SUBJECT: Council Request CR 17-198: PUD Rezoning for 1327 W. Tufts Ave.

Attached please find all of the items submitted to the Development Review Team (DRT) and the associated plan review comments from City staff for the proposed PUD rezoning at 1327 W. Tufts Ave. The proposed conceptual plans have evolved since last April with the applicant making plan revisions to respond to technical comments. Three different DRT case numbers were assigned as the project evolved, they are described briefly below.

Project Number	DRT2017-019	Applied	4/18/2017	JKL
Project Name	Potential PUD for townhomes	Approved		
Type	DRT	Closed		
Subtype	SITE DEVELOPMENT	Expired		
Status	STAFF REVIEW	Status		
Owner	1327 WEST TUFTS AVENUE LLC	Applicant		
Site Address		City		
1327 W TUFTS AVE		ENGLEWOOD	State	Zip
			CO	80110-5524
Subdivision		Tract	Block	Lot No
				Parcel No
				2077-09-1-00-020
Zoning		General Plan

Project Number	DRT2017-036	Applied	7/24/2017	NGF
Project Name	Site Development Possible PUD	Approved		
Type	DRT	Closed		
Subtype	SITE DEVELOPMENT	Expired		
Status	STAFF REVIEW	Status		
Owner	West Tufts LLL	Applicant	West Tufts LLL	
Site Address		City	State	Zip
1327 W TUFTS AVE		ENGLEWOOD	CO	80110-55

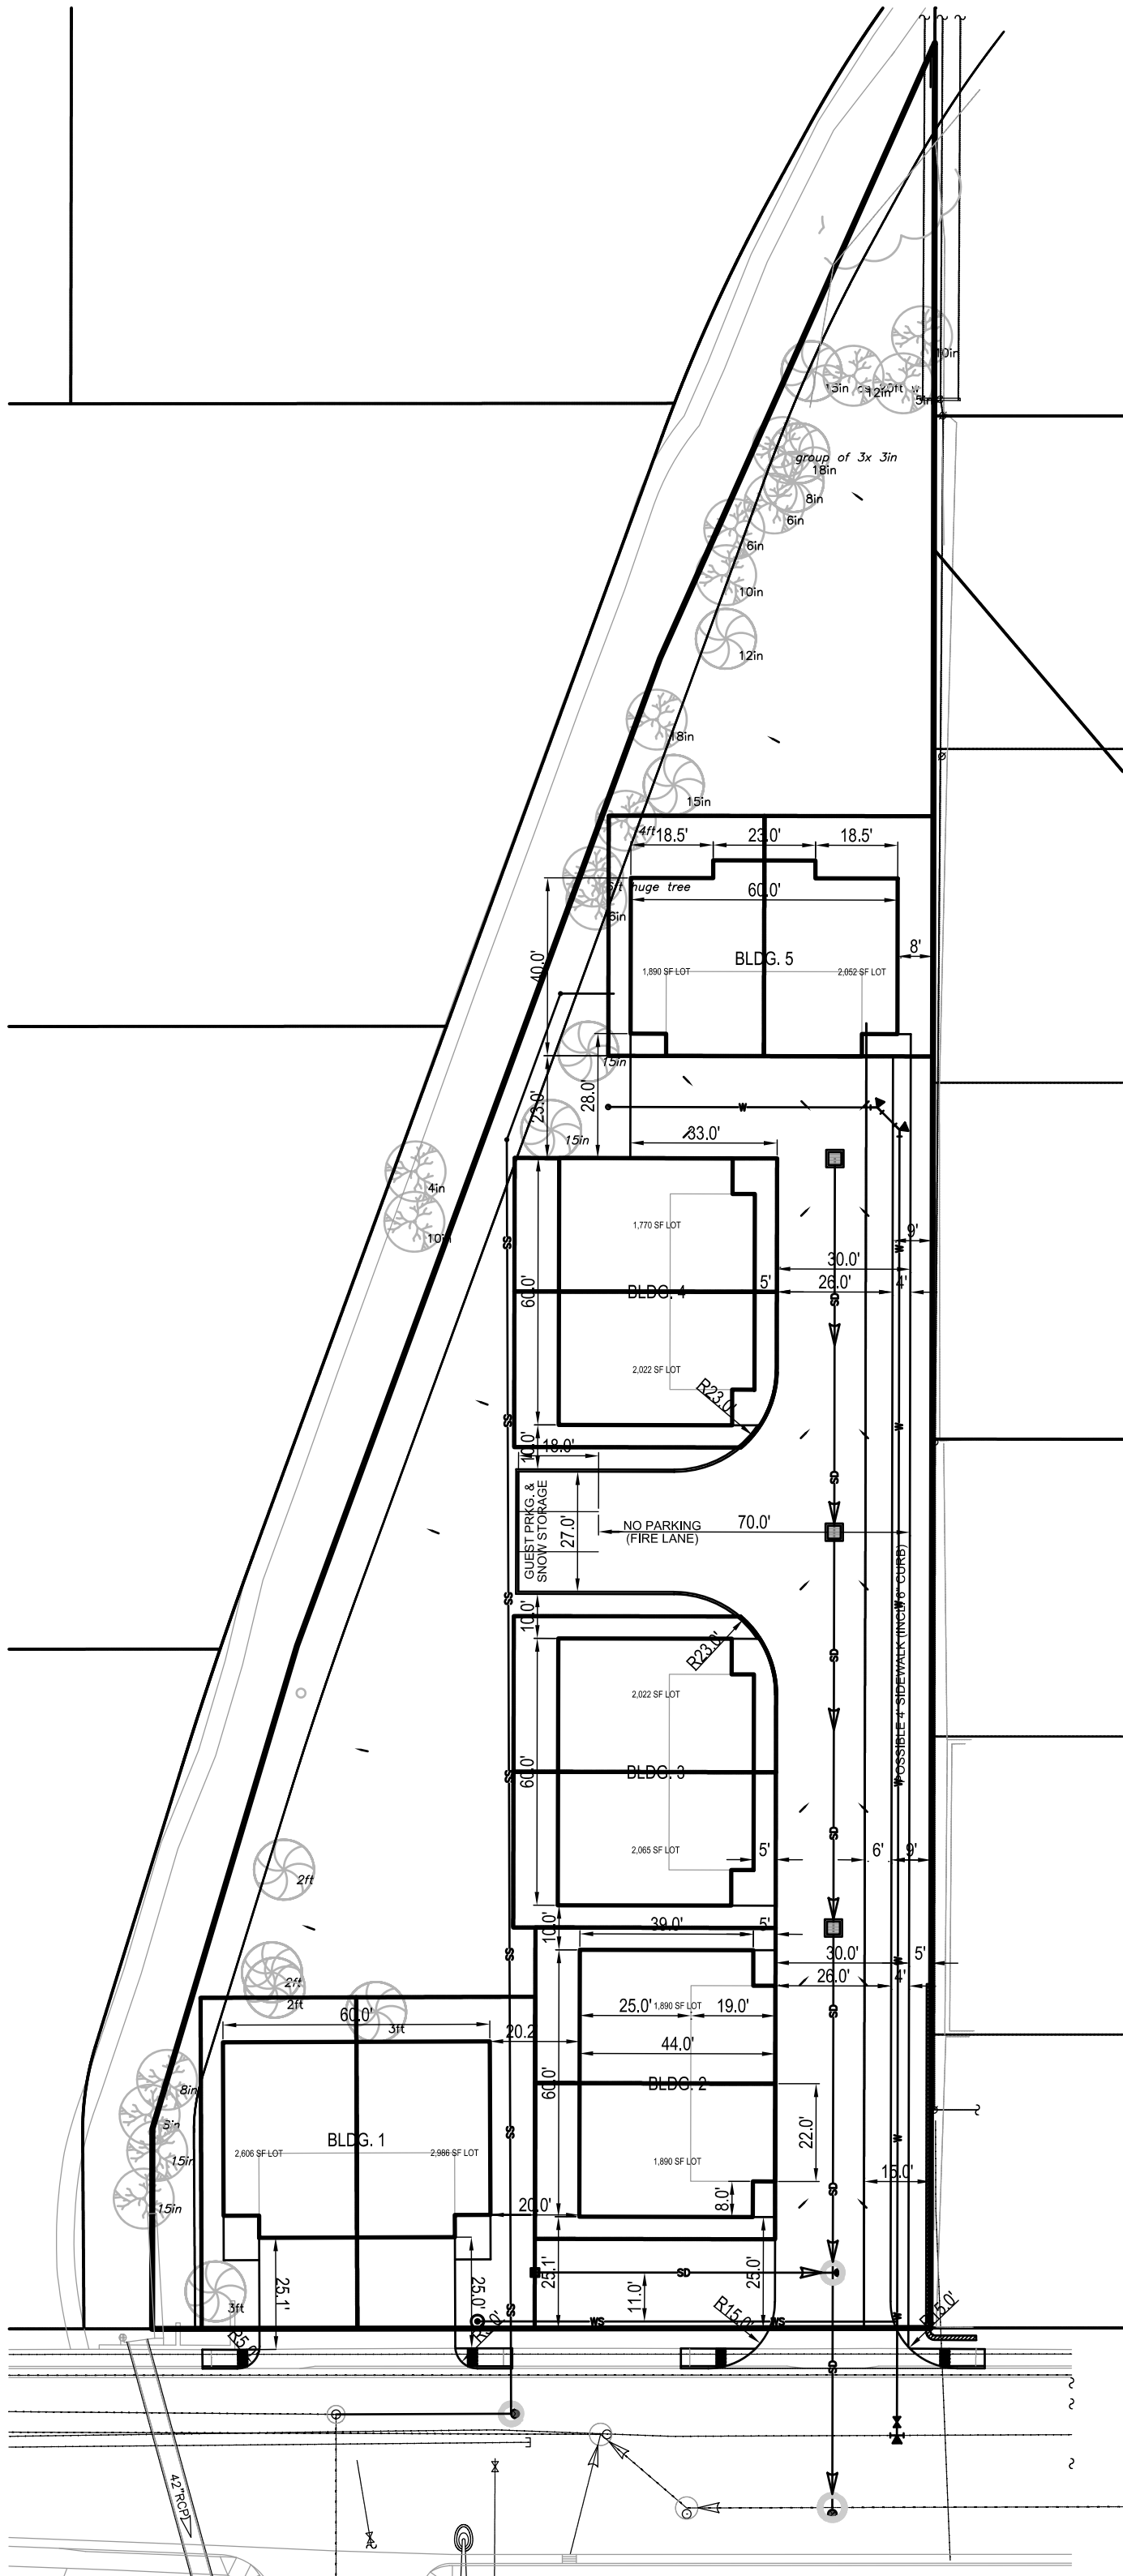
Although the onsite access is private, consider the ease of maneuvering in and out of the garages when developing the site.

Water quality features need to be implemented into the development plan and detailed in the drainage report.

The drainage report shall discuss and analyze the impact of the increased runoff to the existing infrastructure (i.e. inlets and storm sewer on Tufts)

The site runoff shall not drain to the city ditch

To further clarify, the site shall be designed to capture and provide water quality (through a water quality feature(s)) for runoff from areas in which newly developed imperviousness is planned.

Total runoff from the site should be quantified in the drainage report and analysis/calculations be provided to determine impact of increased runoff to the existing infrastructure (i.e. inlets and storm sewer)

1) pervious areas will be allowed to drain towards the city ditch as historically done. All runoff from new impervious areas will need to be directed to the municipal storm sewer system.

1) All runoff from new impervious areas will need to pass through a water quality feature prior to entering the municipal storm sewer system.

Per conversations with Jason Clark and Utilities, pervious areas will be allowed to drain towards the city ditch as historically done. Runoff from impervious areas will need to be directed towards the city municipal storm sewer system.

for the PUD submittal, please provide a drainage report to discuss historic drainage patterns, and impact to the existing municipal storm sewer system, it shall provide calculations for historic and proposed runoff and imperviousness. The report shall also discuss water quality features and provide details and capacity calculations as needed.

All onsite storm sewers, inlets and water quality features (stormceptor) shall be noted as private on the plans and it shall be discussed in the drainage report that they are private and will be maintained by the owner.

The fire hydrant needs to be relocated for accessibility. Please relocate mid-block.

Not Approved as drawn; per email exchanges, the following must be identified in order to provide FD approval:

26' clear width required for access- No parking would be allowed on the street or within dedicated fire apparatus access locations. Signage would be required.

A fire hydrant would need to be added

The 26' width (exclusive of shoulders) is the required minimum as adopted (2012 IFC with amendments) and the templates as amended for Appendix D-per Figure D103.1.

The 96-foot diameter cul-de-sac shall be 26' wide, with a 28' radii.

The 120' hammerhead shall have a 26' wide access width, 28' radii and 60' wide head.

The 60' Y shall be 26' wide, 26' radii and 60' Y (see figures D103.1

Traffic (303)762-2512 APPROVED NICK JOHNSON <i>njohnson@englewoodgov.org</i> (9/21/2017 3:56 PM NCJ) Driveway on tufts should be 20 feet wide.	11/17/2017	11/28/2017	11/30/2017	13	
UTILITIES (303)762-2647 APPROVED W/COND KONAD KRORI <i>kkrori@englewoodco.gov</i> (8/2/2017 1:20 PM BWK) Utilities needs to see proposed utility plan. (8/2/2017 1:21 PM BWK) U09 - Each building shall be served by a separate water service and a separate sewer service connection directly to the nearest main,	11/17/2017	11/28/2017	12/1/2017	14	SEE NOTES

The fire hydrant should be moved to a mid-block location as per fire dept. comment. At the north-end of the water main, a blow-off should be shown in place of the fire hydrant which is being moved. A metered irrigation connection could be made at this location which will ensure water movement during the summer months.

The water main should be upsized to 6" dia.

Due to water quality issues related to the water main essentially dead-ending at the north end, the water main has to remain public so that city water distribution personnel can operate the blow-off periodically and also maintain the main. For the same reason of water quality, the (4) units fronting W. TUFTS AVE. should have their water taps off the active 6" water main running in W. TUFTS.

Each of the (10) units will require ¾" water service lines, ¾" curb stops and ¾" water meter/vaults. Curb stops and meter vaults shall not be installed in the paved area but in open grassy areas in front of the units or next to them.

Both water and sanitary sewer mains shall require to be easemented. Along the east side, the water main need to be shifted west so that there is a 5' wide clearance from the edge of the pavement.

A larger turn-around would be required at the north-end of the site for fire and city utility trucks to turn-around. Refer to previous fire dept. comments dated 9/19/2017 for dimensions.

In regards to the utility easements, the requirements are 15' wide easement for (1) buried utility and 25' wide for a combined easement for (2) utilities. Hence, it would be practical to just easement all of the 26' wide alley.
